**SOLICITATION AMENDMENT
MODIFICATION DE L'INVITATION**

Title - Sujet CCGS PIERRE RADISSON VESSEL LIFE EX	
Solicitation No. - N° de l'invitation F7049-160074/A	Amendment No. - N° modif. 011
Client Reference No. - N° de référence du client F7049-160074	Date 2016-07-13
GETS Reference No. - N° de référence de SEAG PW-\$\$MD-031-25863	
File No. - N° de dossier 031md.F7049-160074	CCC No./N° CCC - FMS No./N° VME
Solicitation Closes - L'invitation prend fin at - à 02:00 PM on - le 2016-07-25	Time Zone Fuseau horaire Eastern Daylight Saving Time EDT
F.O.B. - F.A.B. Plant-Usine: <input type="checkbox"/> Destination: <input checked="" type="checkbox"/> Other-Autre: <input type="checkbox"/>	
Address Enquiries to: - Adresser toutes questions à: Bilodeau, Allen	Buyer Id - Id de l'acheteur 031md
Telephone No. - N° de téléphone (819) 420-2912 ()	FAX No. - N° de FAX () -
Destination - of Goods, Services, and Construction: Destination - des biens, services et construction:

La modification n° 11 vise à publier les items suivants.

CCGS Pierre Radisson VLE 2016 - # F7049 – 150372/A

Actuator Scupper Valve Details

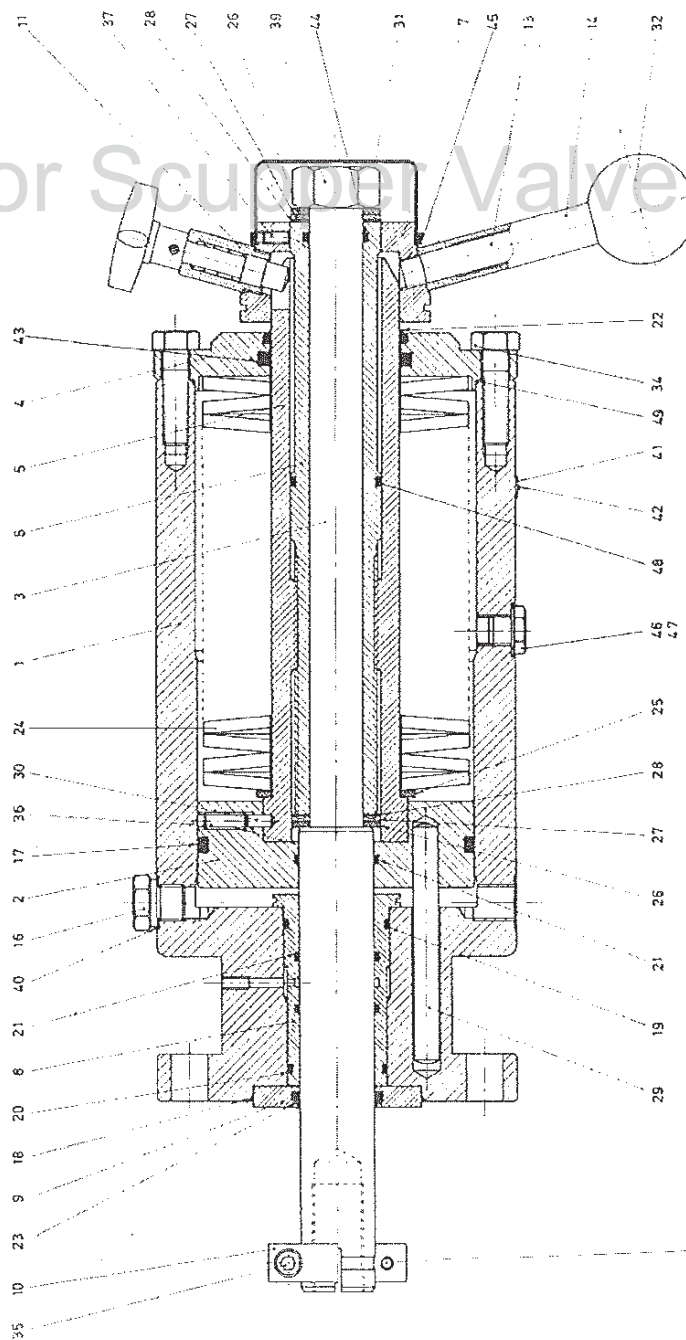
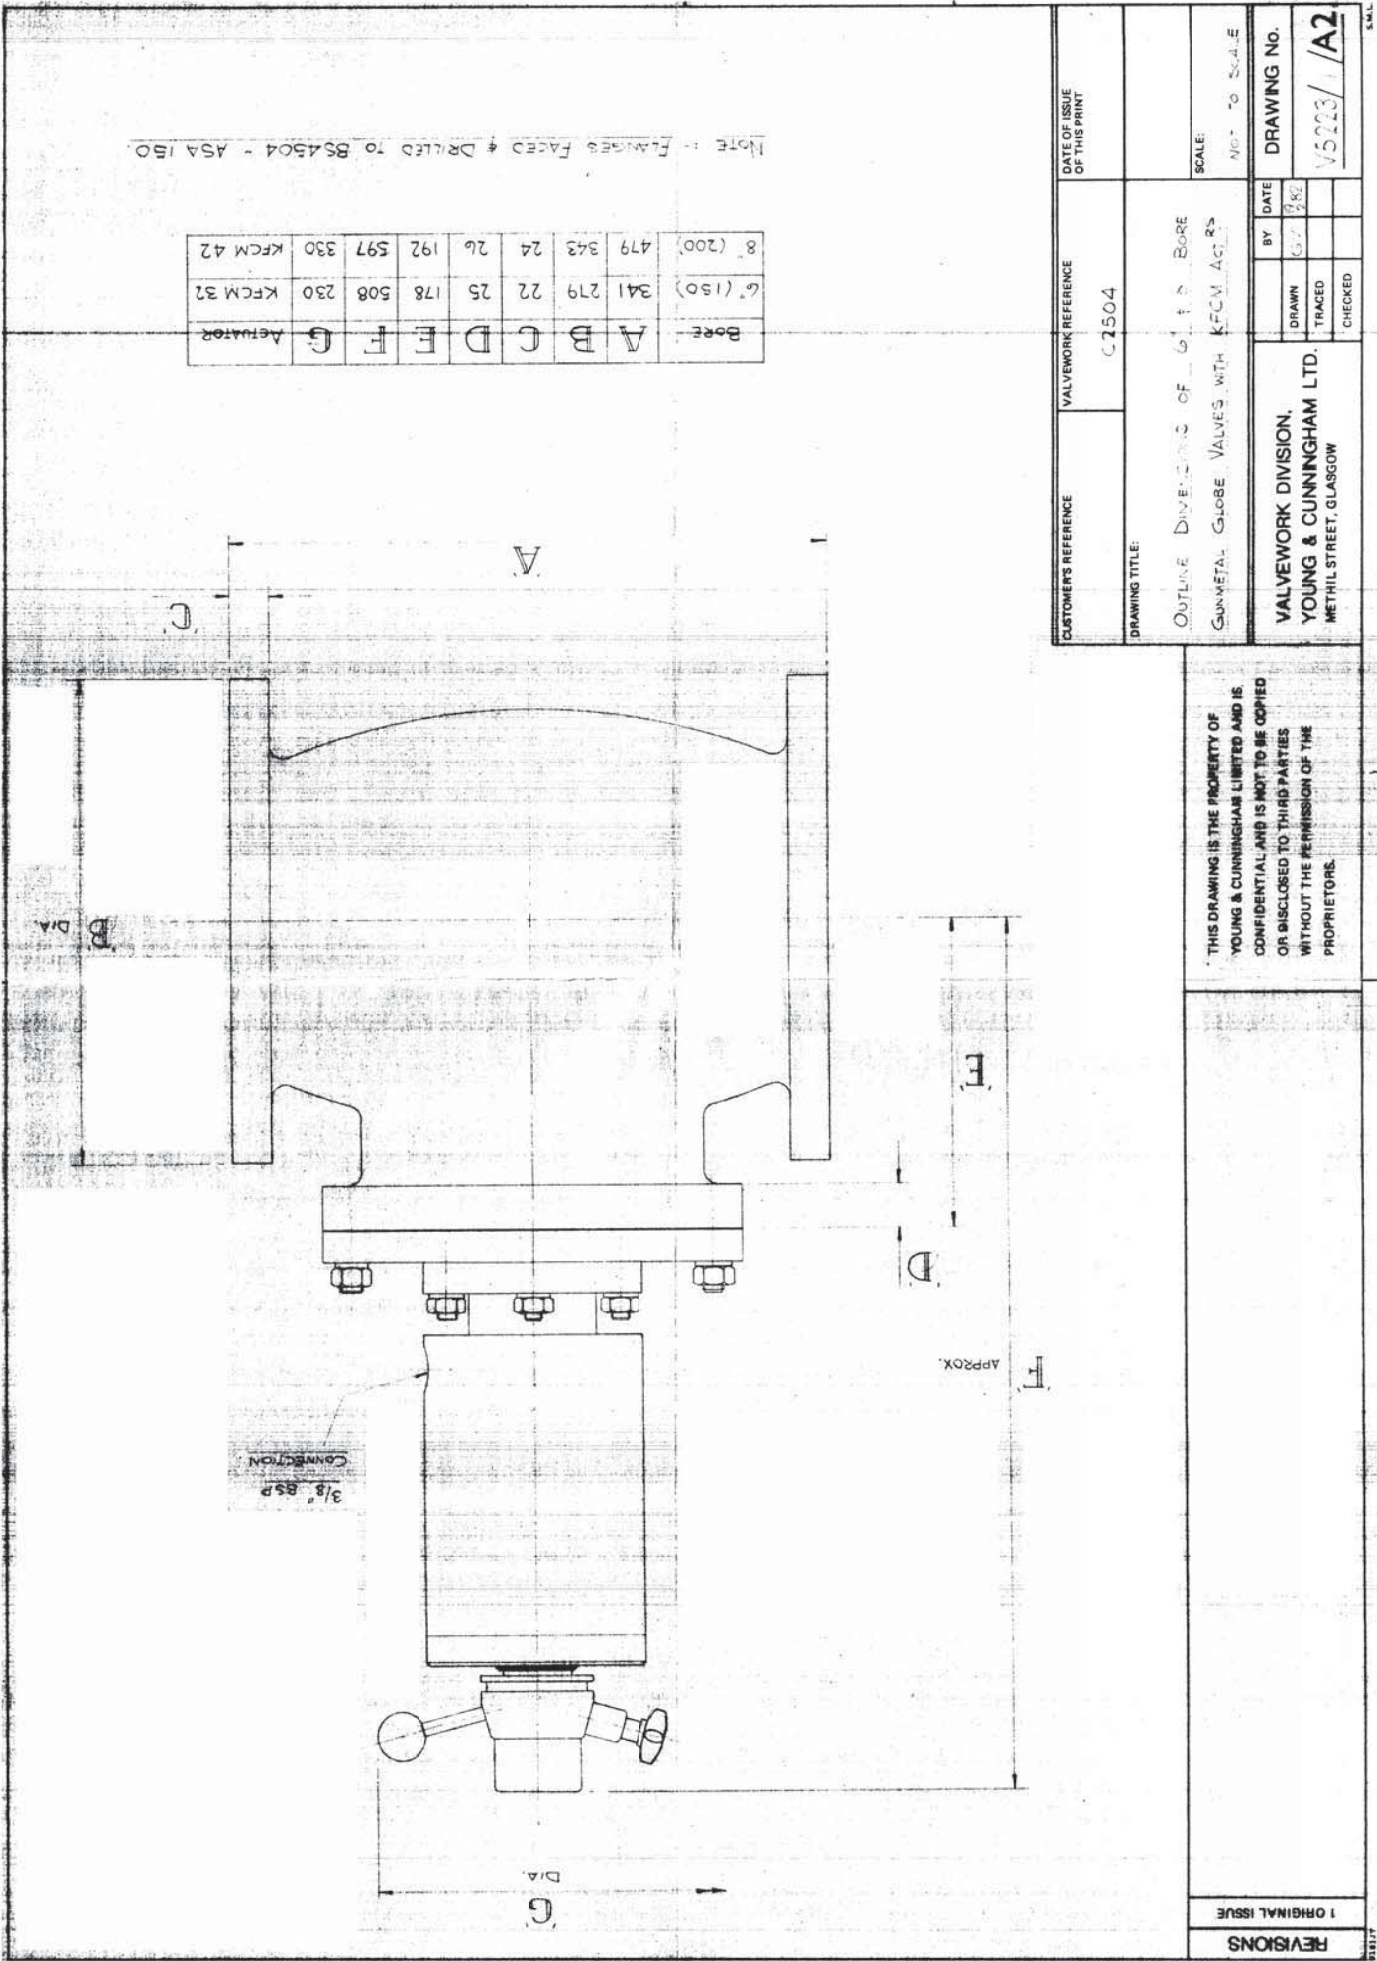
Q15	We are requesting a one week extension to the closing date due to the change of the windows in spec 42 from government supplied material to contractor supplied material	A15	The solicitation closing date has been extended to July 25th.
Q16	A supplier cannot supply a TCMS certificate for these windows, however they are approved by class. Will coast guard accept the class certificate?	A16	Refer to Amendment 10, item 3, amended sub-section 42.2.4.1: " ... approved by Transport Canada or a classification society recognized by Transport Canada."
Q17	Due to the number of amendments & changes to the tender/bid package that are coming out for the Pierre Radisson, we feel that in order to submit a competitive and compliant bid, we require a 2 week extension to the current submission deadline	A17	The solicitation closing date has been extended to July 25th.
Q18	Section 31.2.2 of the spec., there should be a Young and Cunningham instruction Manual with the drawings which doesn't appear to be included. Can you please provide us with this document?	A18	Instruction booklet referred at Section 31.2.2 is the document entitled "Soupapes de dalot_Instruction.pdf" included under Section 32 of the TDP. Three additional documents on valve drawings and technical details are added to Section 31.2.2.

2. Modification à l'Annexe A, Section 32.2.2, Références

- Trois documents mentionnés à la réponse 18 sont ajoutés à la sous-section 32.2.2. Les documents sont intitulés Un document intitulé « Actuator Scupper Valve Danfoss », « Young & Cunningham Valve 5223 » et « Young & Cunningham Valve 5224 ».
